November 24, 1999

RE: *Drainage Report and Grading and Drainage Plan for Pete Riboni, Canyon De Carnue Grant Fill Area Limits, (L26/D2) (PWDN-990221) Engineer's Stamp Dated 11/8/99.*

Susan M. Calongne, P.E.
City/County Floodplain Administrator

LIMITS OF FILL AREA &
EXISTING FLOOD PLAIN

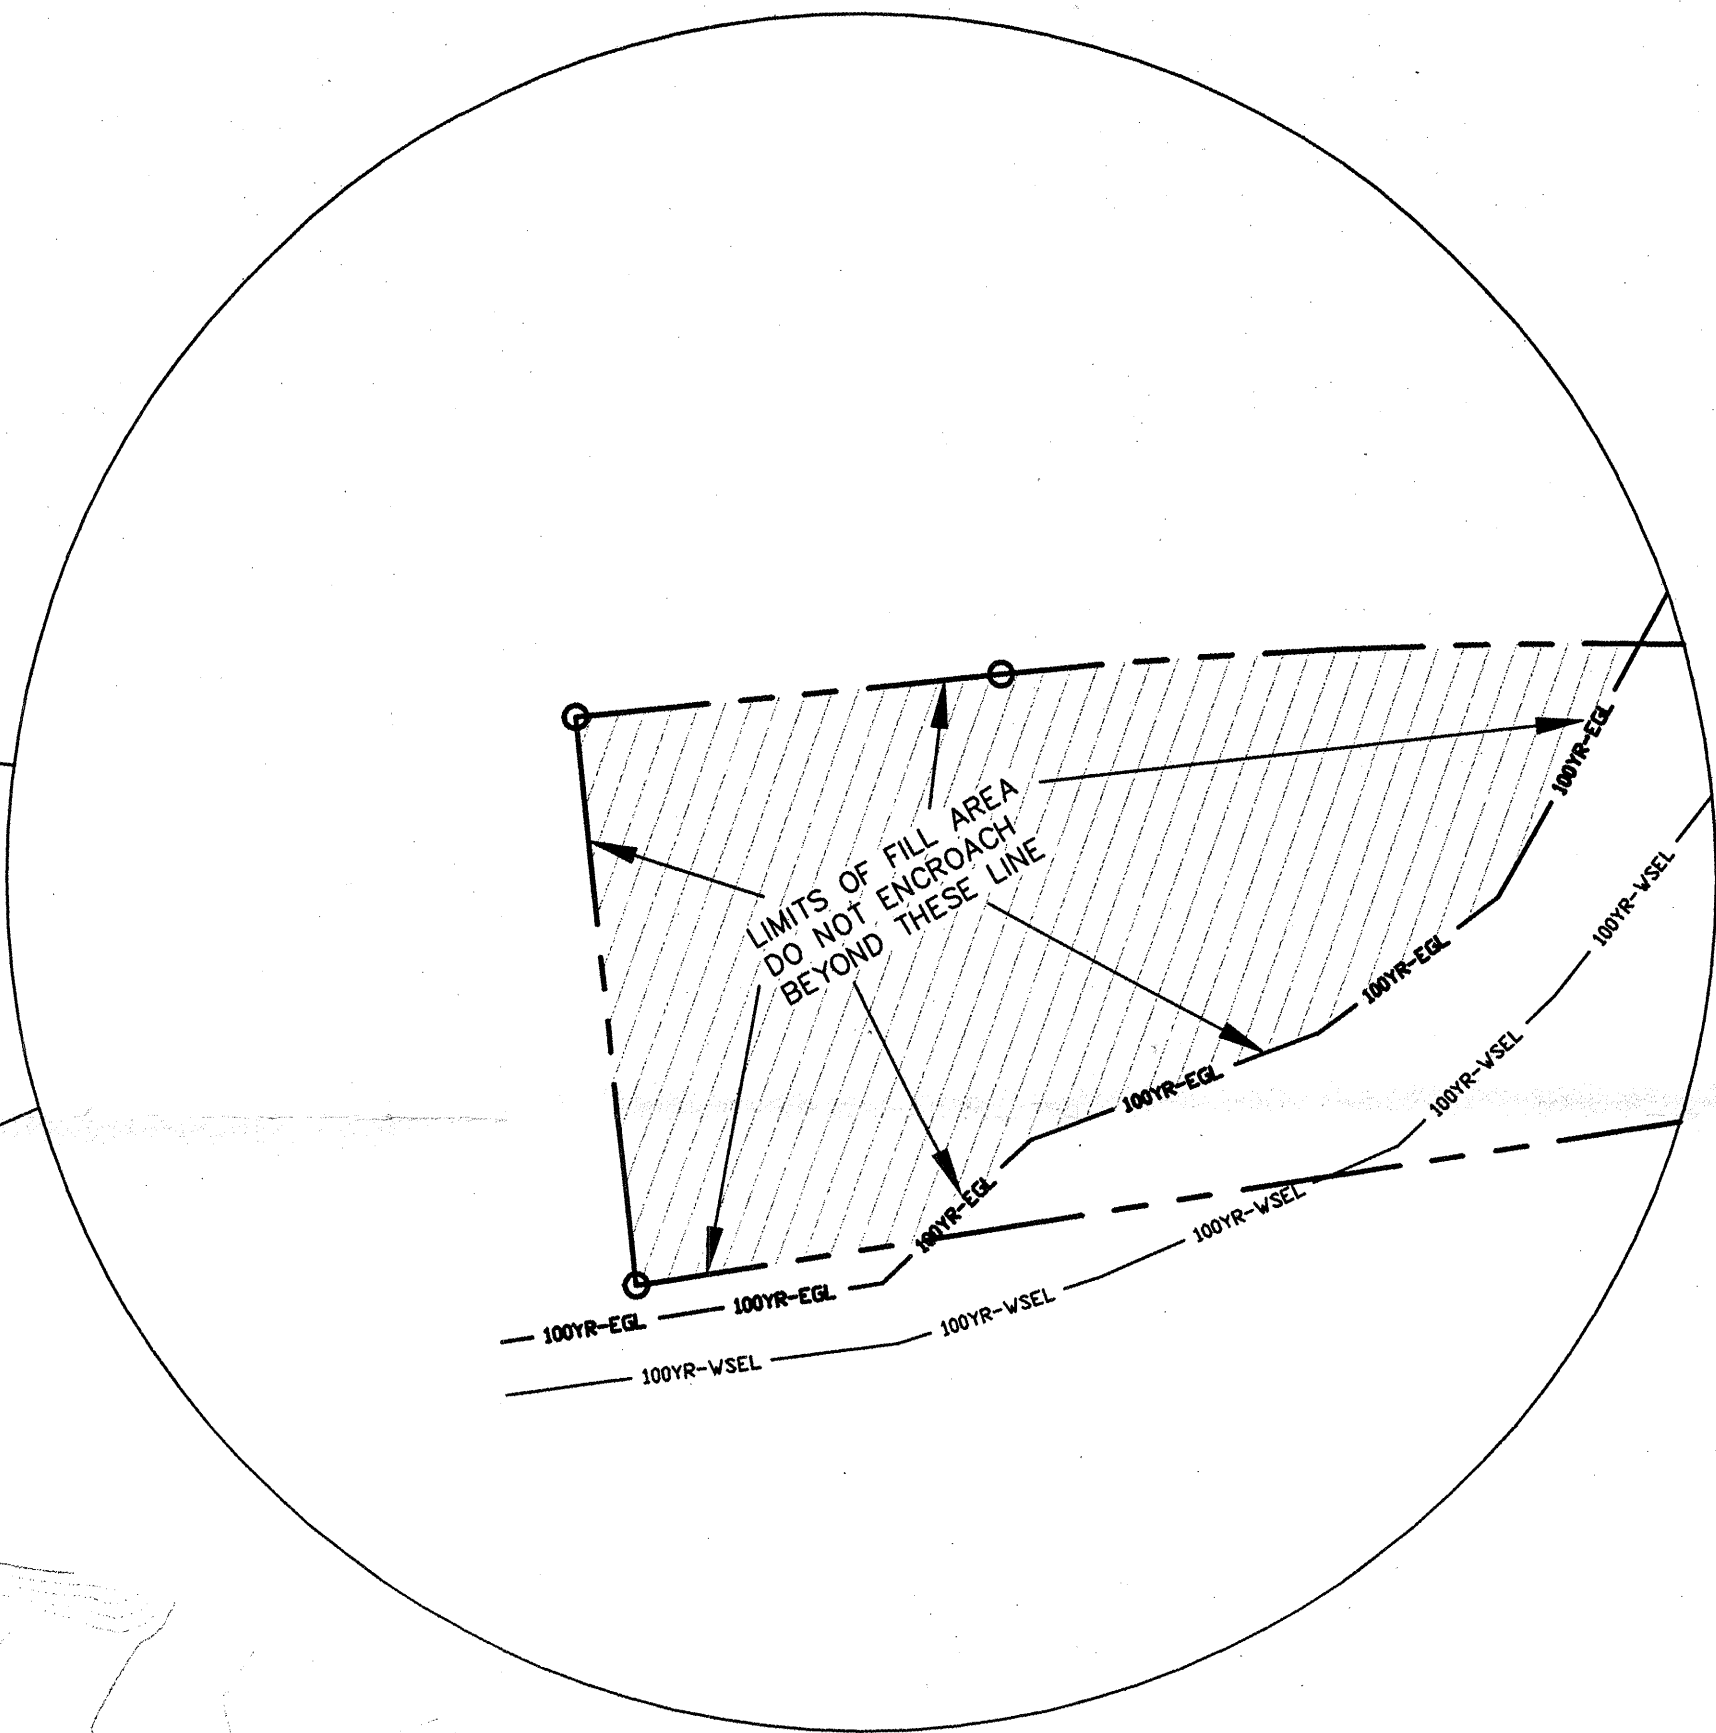
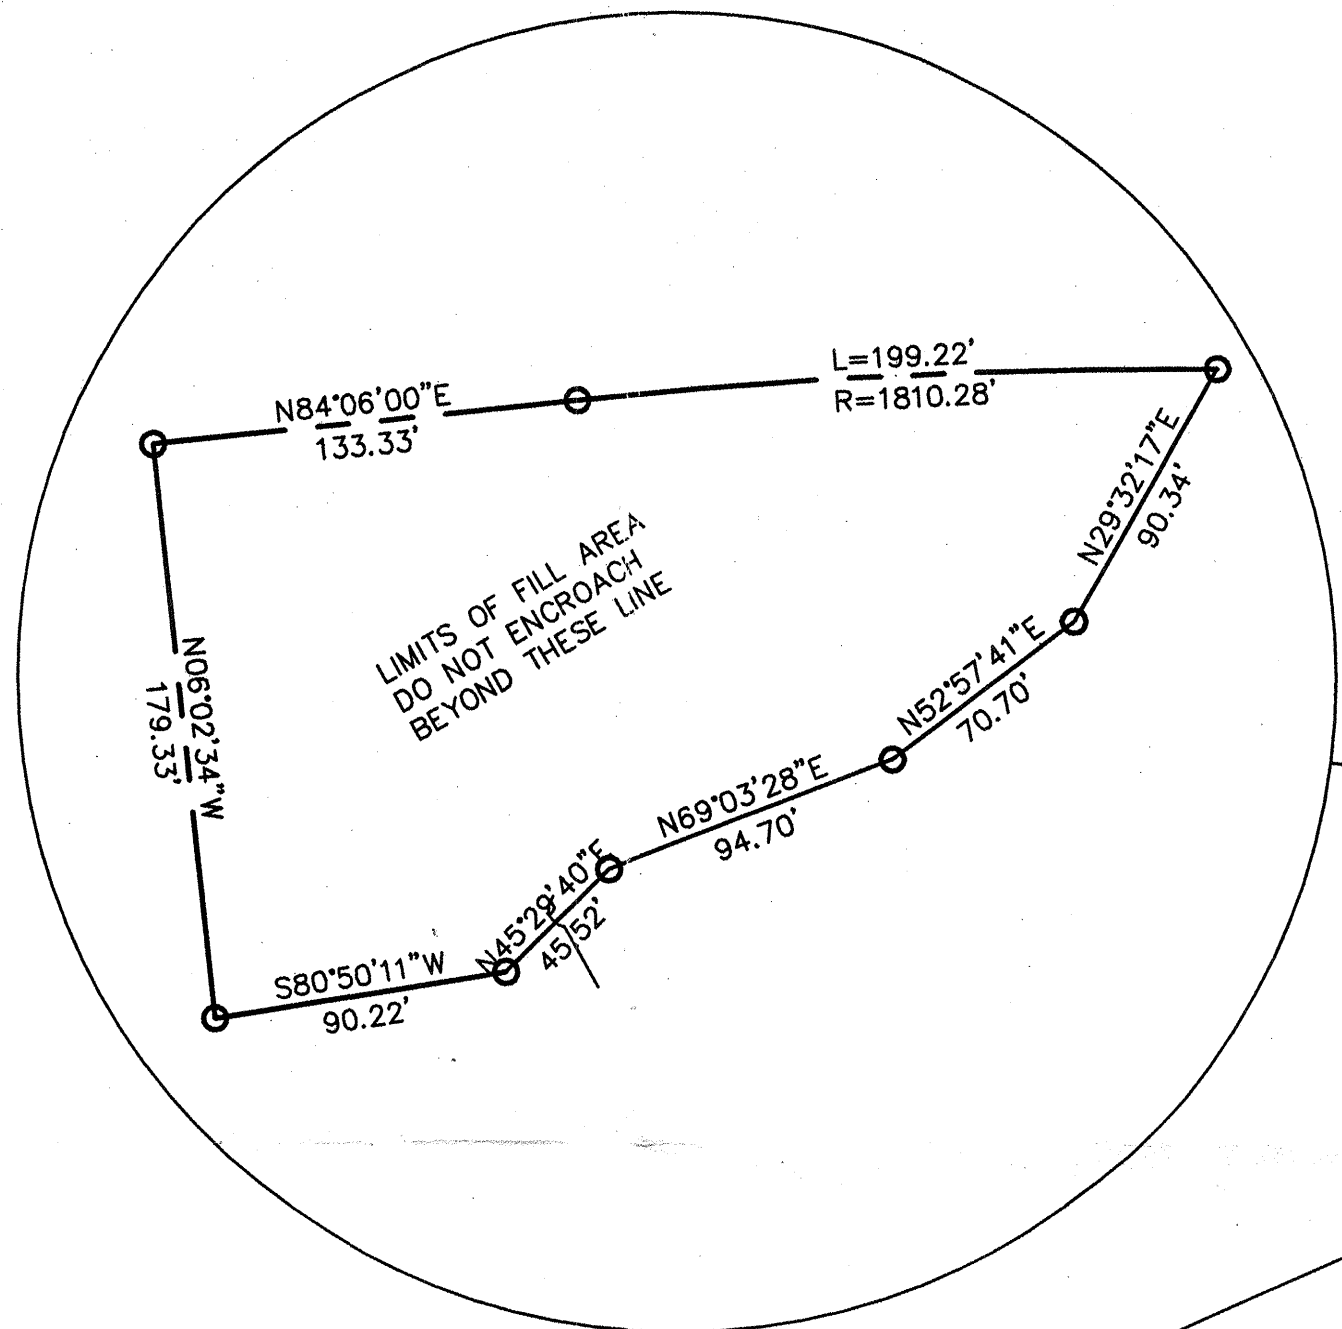
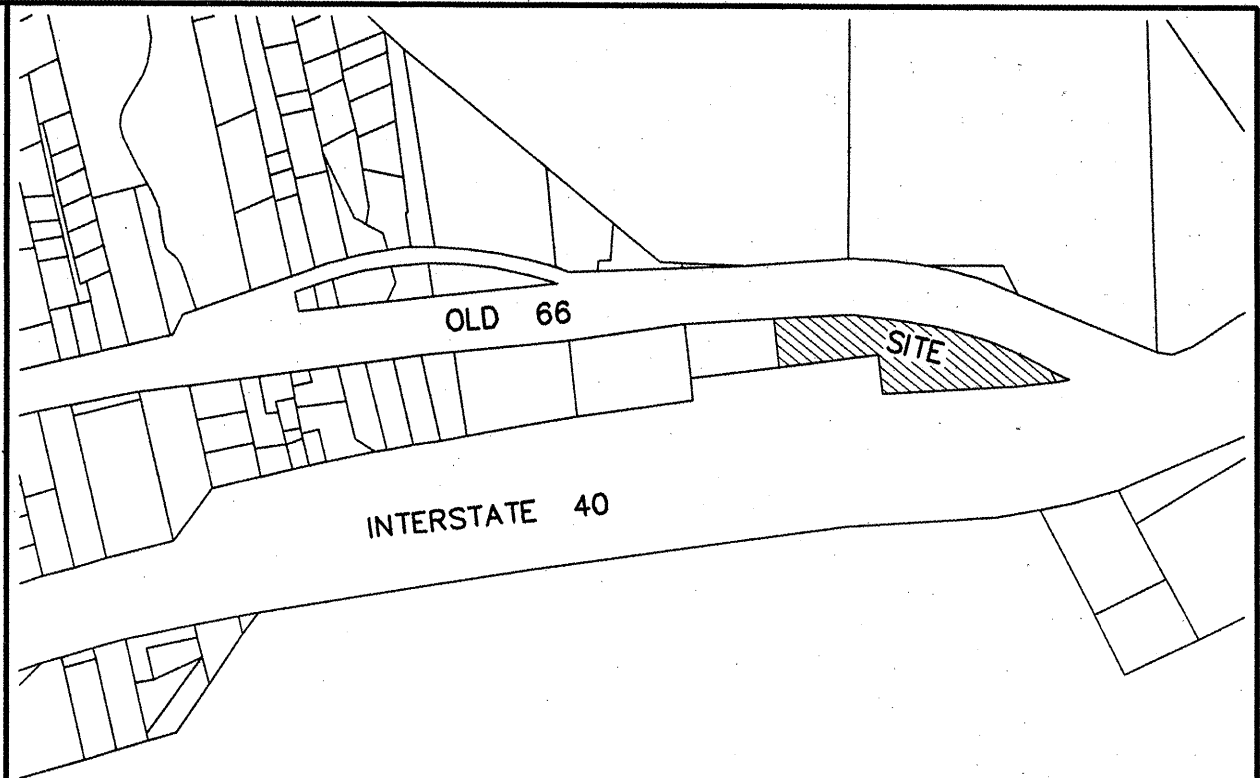
The above referenced plan proposes only to place fill material in the northwest corner of the site. Based on the information provided, this plan is approved for release of the Grading permit for this project. Please be sure that the fill area is staked out in the field per this plan.

Prior to future development on this site, or Building Permit release, a site-specific Grading and Drainage plan will be required. At that time, an Easement for the area within the FEMA floodplain must be granted to the County.
